April 2017
FL724A-Q
NHTSA #16V-666 (Non-School Buses)
NHTSA #16V-664 (School Buses)
SECOND REVISED NOTICE

Subject: ICU3S Instrument Cluster Hydraulic Brake Telltale

Models Affected: Specific Freightliner Business Class M2 vehicles and Freightliner Custom Chassis S2 bus and B2 (Thomas Built Buses C2 Saf-T-Liner) school bus chassis manufactured March 3, 2015, through September 8, 2016.

Fig. 1, "Park" Telltale - Replace ICU3S

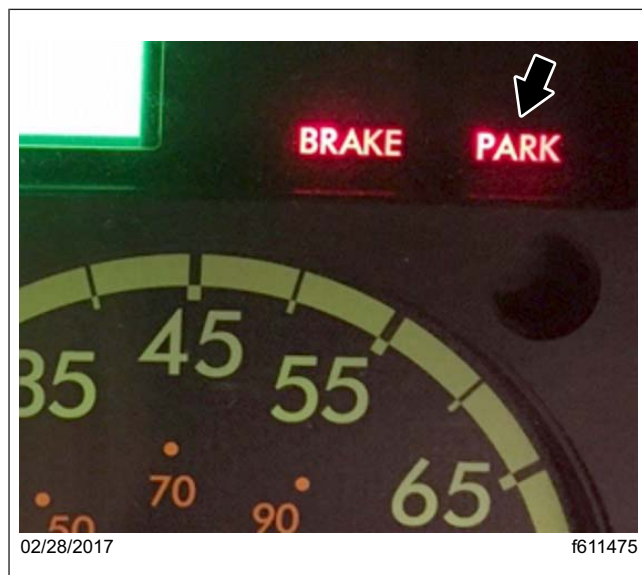
1. Check the base label (Form WAR259) for a completion sticker for FL724 (Form WAR260) indicating this work has been completed. The base label is usually located on the passenger-side door, about 12 inches (30 cm) below the door latch (trucks) or over the driver's window (buses). If a completion sticker is present, no work is needed. If a completion sticker is not present, proceed to the next step.
2. Park the vehicle, shut down the engine, and apply the parking brakes. Chock tires.
3. During the bulb check at key-on, inspect the telltales on the ICU3S (affected telltales will be illuminated for three seconds). See [Fig. 1](#) and [Fig. 2](#)

If the ICU3S has a "Park" telltale, continue with the next step.

Fig. 2, "Brake" Telltale is OK - No Replacement

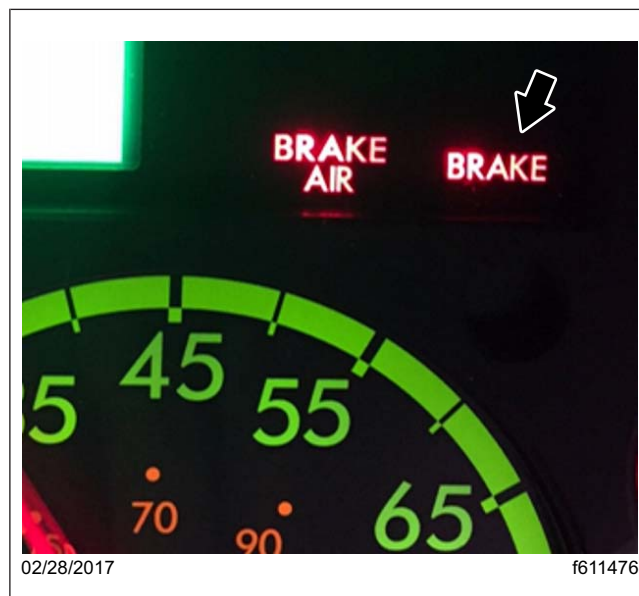
If the ICU3S has a "Brake" telltale, no further work is needed. Clean a spot on the base label (Form WAR259), write the recall number, FL724, on a red completion sticker (Form WAR260), and attach it to the base label.
